Subject: Reply to Request for additional information for FCC ID: VPWVTGTRG1

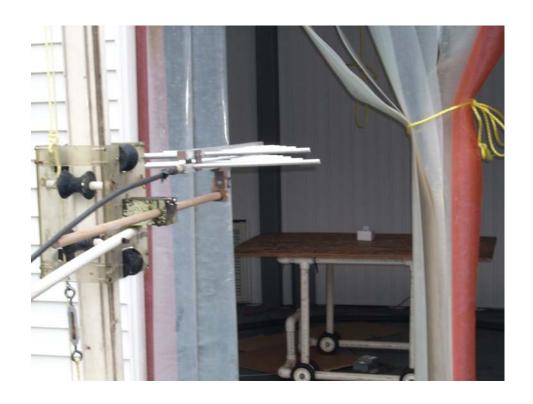
3) Provide a better test set up pictures that show clearly the test lab antenna mast and turntable.

Response: Please find attached pictures.
